The Potential for Imminent Endangerment to Human Life and the Environment from the Mirador Open Pit Copper Mine in Southeastern Ecuador

Submitted to the InterAmerican Commission on Human Rights

Submitted by:

E-Tech International

Figure 10. Surface water sampling locations on Rio Wawayme and waste rock and open pit facilities

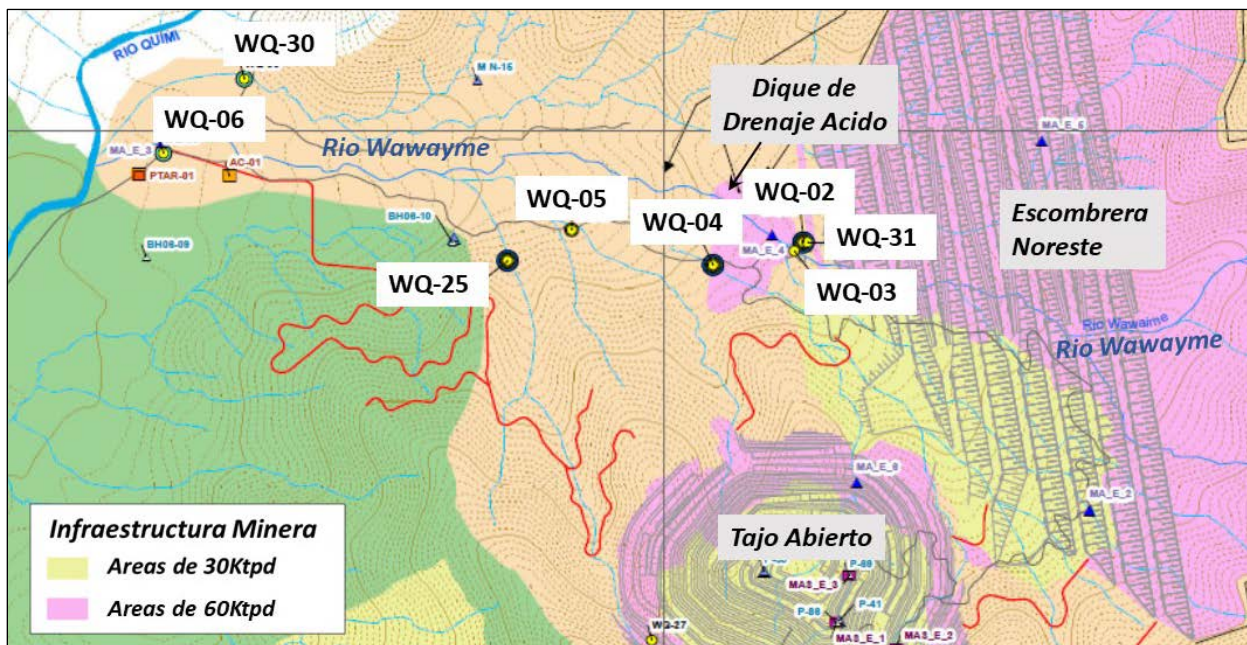
Rio Wawayme drains the large waste rock pile known as Escombrera Noreste, and surface water monitoring locations close to the piles and just upstream of where it flows into the Rio Quimo have water quality standard exceedences of many metals, including copper, iron, aluminum, lead, manganese, and zinc and low pH values (< pH 6). The locations with the highest metal concentrations and lowest pH values are WQ-04, WQ-05, and WQ-34, which are located in tributaries to Rio Wawayme that drain Escombrera Noreste and the open pit (Table 1 and Figure 10³). Metal concentrations near the mouth of Rio Wawayme (WQ-06) were generally lower and pH values were somewhat higher, based on limited additional data obtained as part of the information requests. The elevated metal concentrations and low pH values compared to pre-mining conditions are a strong indication that surface water is adversely impacted by mining and that the contaminants derive from leaching of waste rock in Escombrera Noreste. The lower concentrations farther away from the waste rock pile indicate that the source is the pile, and dilution occurs downstream; however, concentrations are still elevated at the mouth. The results also show that environmental control measures to capture mine-influenced water from the waste pile are not effective.

Figure 11. Mine layout for the 30,000 ton/day operation showing waste rock dumps in the Tundayme and Wawayme watersheds

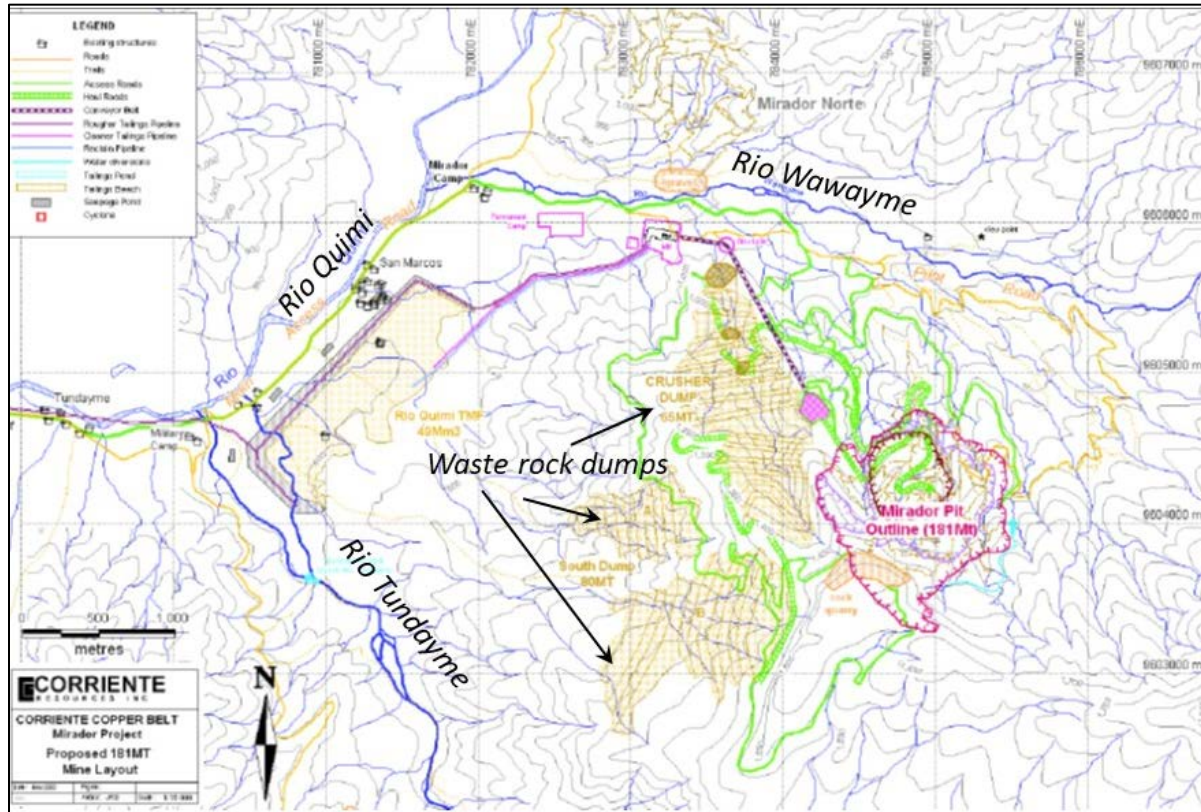
The Contraloria (2020) report also shows elevated concentrations of metals and low pH values in Rio Tundayme and Rio Quimi compared to baseline values (IIGE, 2018) and Ecuadorian water quality criteria. The upper Rio Tundayme receives water from tributaries draining the open pit area, and the lower Rio Tundayme contains the Quimi TDF. The 2008 Feasibility Study (Corriente Resources, Inc., 2008) shows that large waste rock dumps were planned for the west side of the open pit that would drain to the Rio Tundayme watershed, as shown in Figure 11.

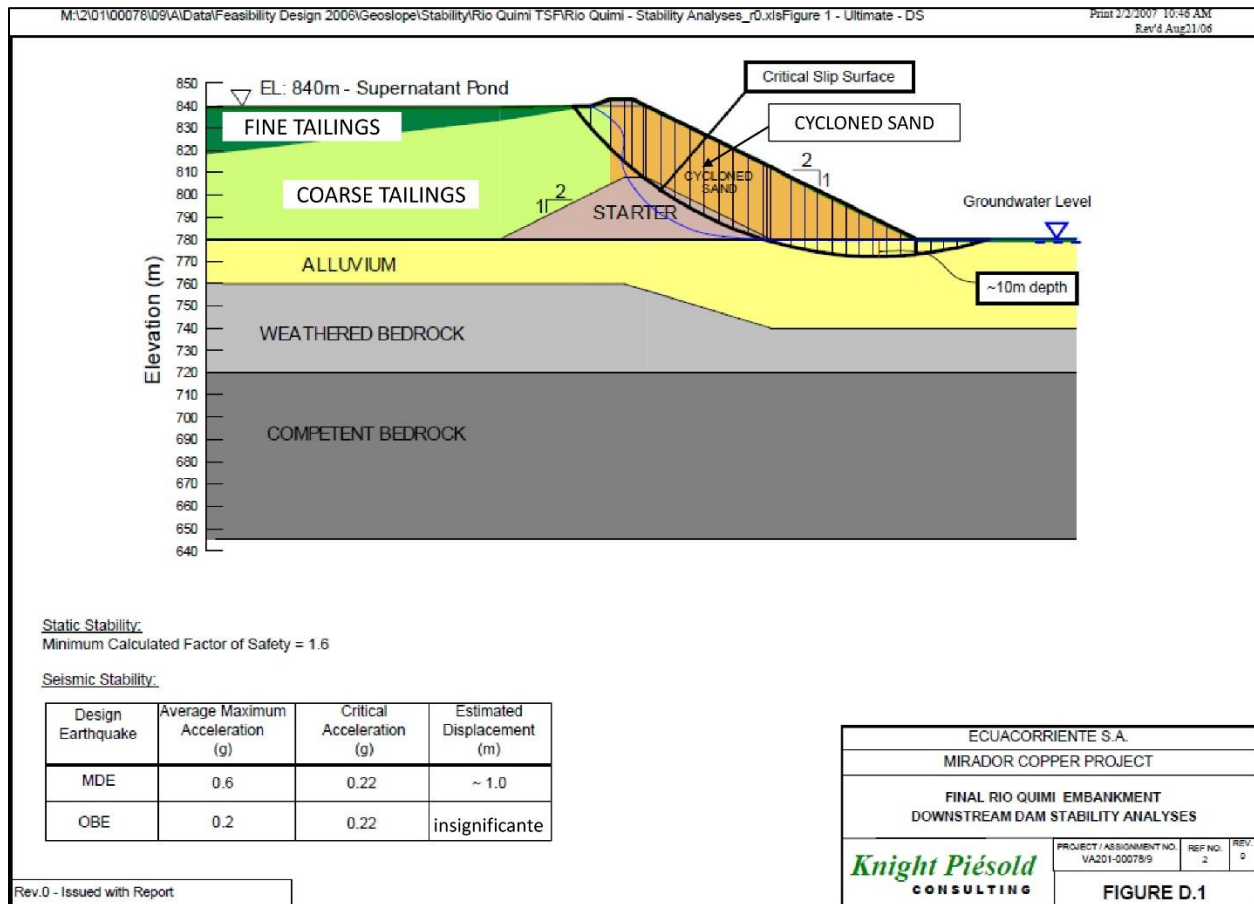
The critical part of the Knight-Pièsold review (2007) was the seismic stability analysis, which said that “the entire depth of the tailings deposit is potentially liquefiable for the MDE and OBE [Operating Basis Earthquake]. Liquefaction is also predicted for the loose alluvial soils near surface (in the upper 10 meters) for the MDE and OBE.” The OBE is the earthquake that is expected to occur during the life of a project. Knight-Piesold (2007) defined the OBE as the earthquake with a return period of 475 years, which is equivalent to an annual exceedance probability of 0.21% and a probability of exceedance during the 30-year life of the project of 6.13%. In other words, Knight-Piesold (2007) said the probability was 6.13% that the entire mass of tailings, as well as the foundation, will undergo seismic liquefaction at some time during the 30 years of the life of the project. However, it should be noted that the risk of seismic liquefaction does not end at the end of the mining project, but continues forever as the dam is supposed to store wet tailings in perpetuity. Knight-Piesold (2007) recommended that “ground improvement to increase the liquefaction resistance of these loose soils will be required within the embankment footprint and for a distance downstream of the embankment. Stability analyses indicate that a 100 meter wide zone of ground will require treatment along the embankment alignment.” However, there were no details nor guarantees that the “ground improvement” would eliminate the possibility of liquefaction of the foundation. There is no evidence that this type of seismic stability analysis has ever been repeated, even when the proposed height of the tailings dam increased.

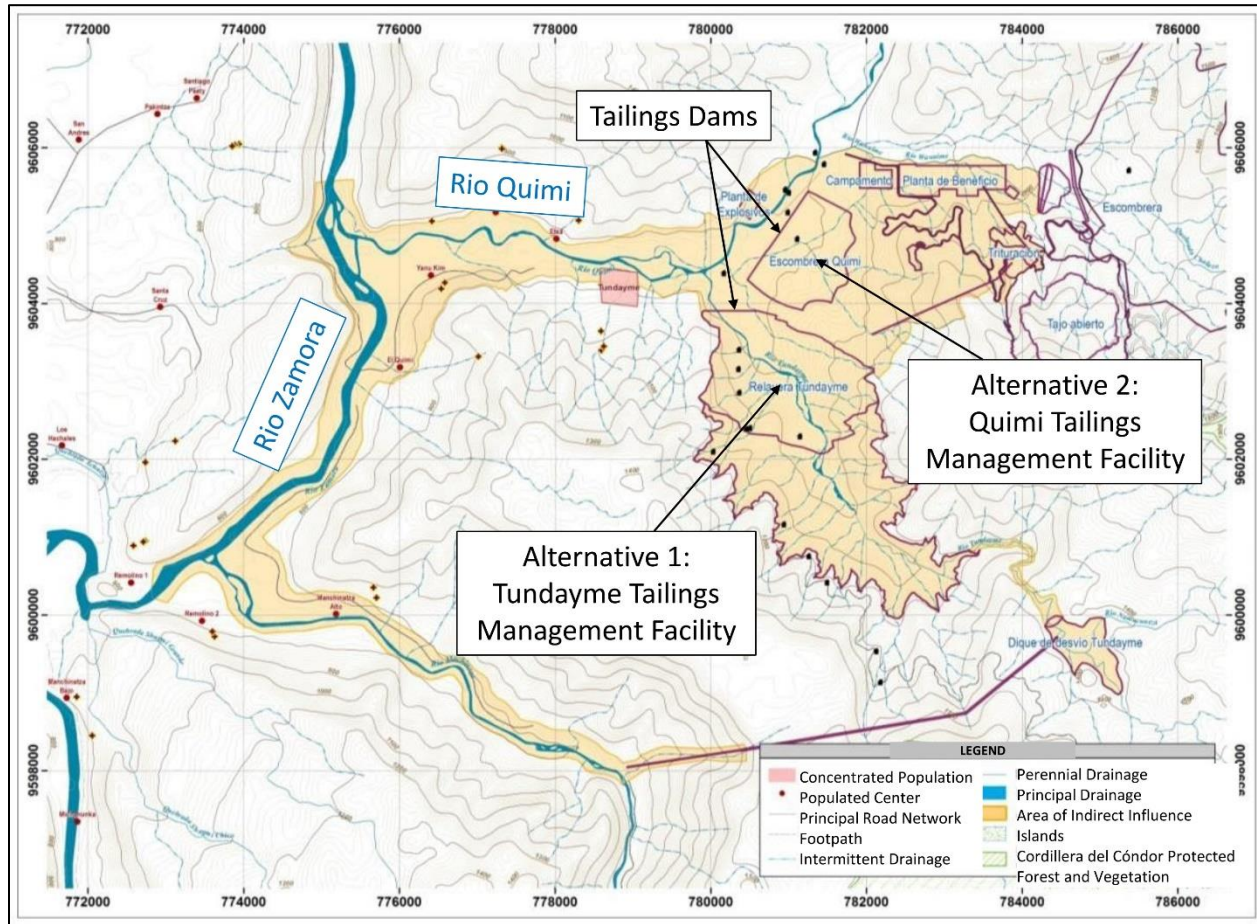
The Tundayme dam had a planned height of 260 meters, which would be the tallest tailings dam in the world. (The current tallest tailings dam is the Quillayes dam at the Los Pelambres mine in Chile (Campaña et al., 2015)). The height of the Quimi dam remained unchanged at 63 meters. The outer embankment slopes were 1:1.5H and 1V:2H for the Tundayme dam and the Quimi dam, respectively. Although the construction methods were never explicitly stated, the discussion of the impermeable layers for both dams made it clear that the upstream construction method was not intended, as discussed above. For example, with respect to the Tundayme dam, Cardno (2014a) wrote “*En el talud aguas arriba del dique inicial se colocarán instalaciones impermeables (una capa impermeable y una capa de filtro). La capa impermeable consiste en geotextil de 2 mm + esteritas de bentonita (4800 g/m²)*” [On the

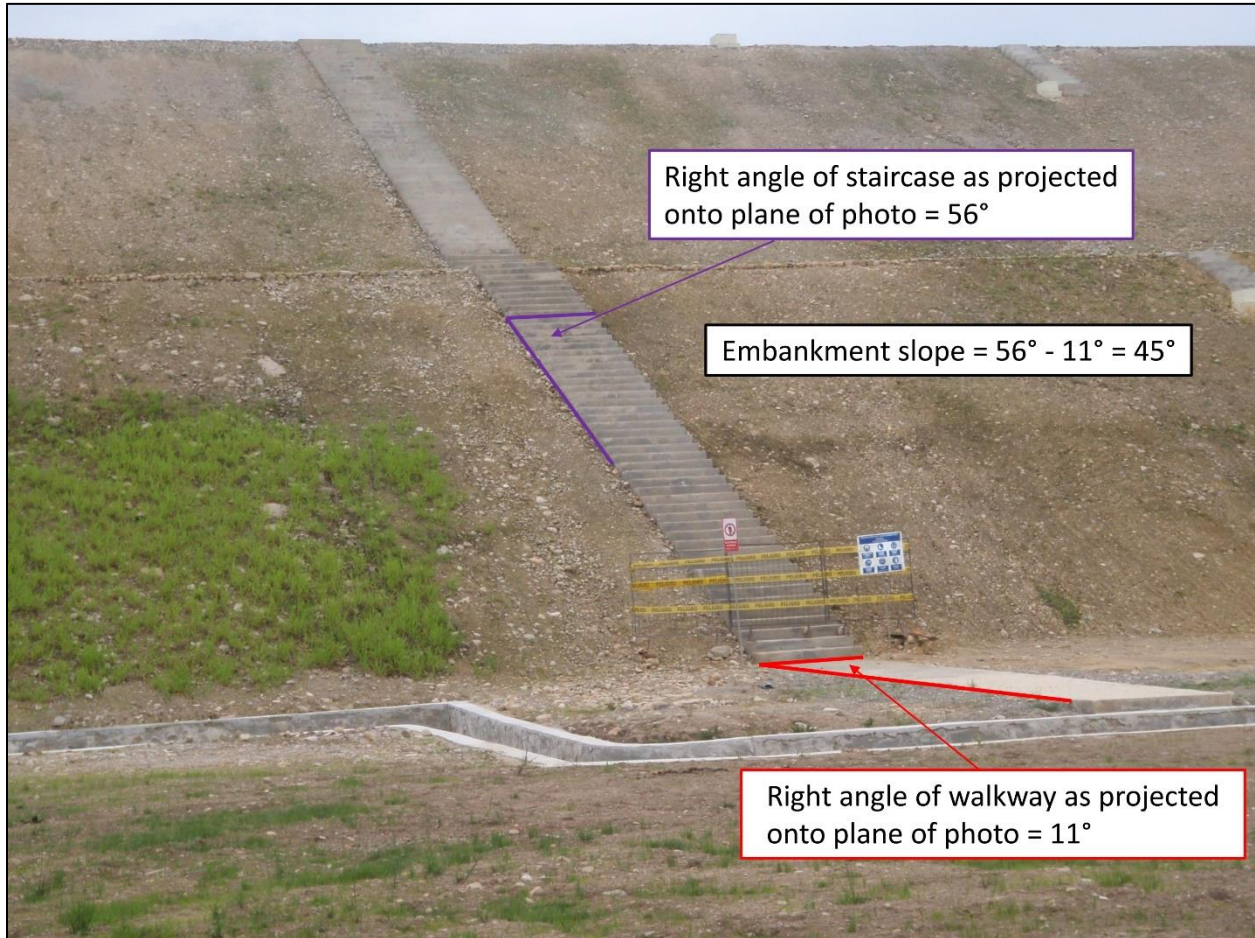
1V:1H is considered to be the maximum critical angle to prevent internal erosion of the dam without any margin of error (safety factor = 1.0). In other words, the starter dike was built at the point of failure, and is in danger of failing as soon as the tailings management facility is filled with wet tailings.

It is impossible to decide which interpretation is correct when there is no apparent connection between the designs and the actual construction. In the same way, it is impossible to determine whether there is an intention to store wet tailings behind the Quimi dam, which would have an unacceptable risk of failure by internal erosion due to its excessively steep slope (see Fig. 17).
